Re: Request for Increase in Maximum Surface Tubing Pressure
Order SWD-1310
Delaware Ranch SWD #1
Mewbourne Oil Company

Mewbourne Oil Company
Delaware Ranch SWD #1
660 FSL & 660 FEL Section 11-26S-28E
3001522734

Current Schematic

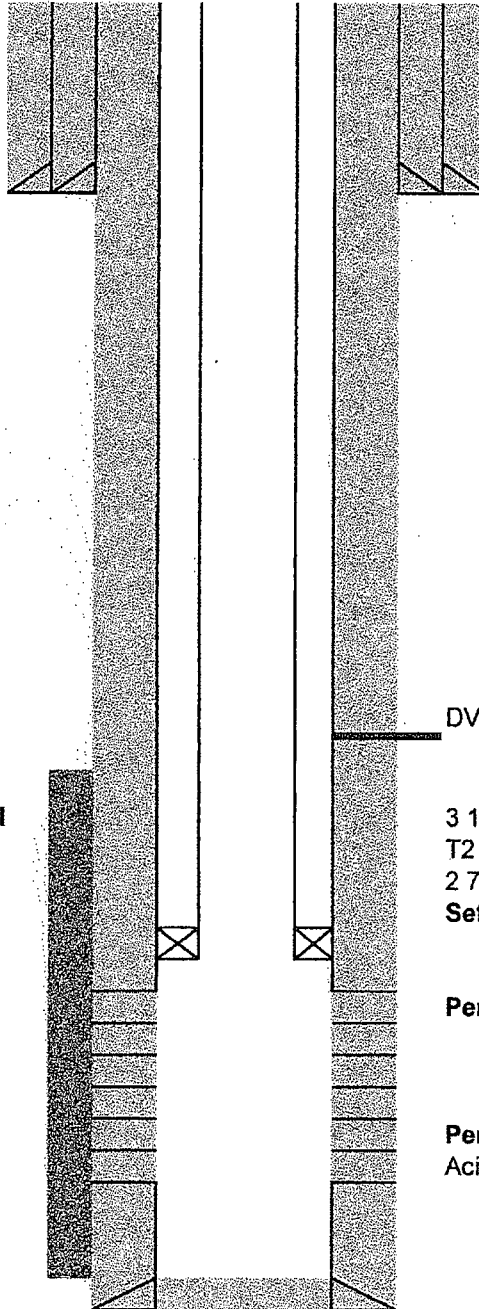
We are proposing to add perforations at 3696' to 4157' to increase the injectivity of the well under the original order SWD-1310. Subsequently, we are requesting that the maximum surface tubing pressure be increased to **739 psi** reflecting the actual top perforation ($0.2 \text{ psi/ft} \times 3696 \text{ ft}$). The current maximum pressure allowed under order SWD-1310 is 534 psi. If approved, the interval open for injection would be between 3696 and 4584'. Please find attached a wellbore schematic with the noted changes.

Perfs 3696-4157 (added)
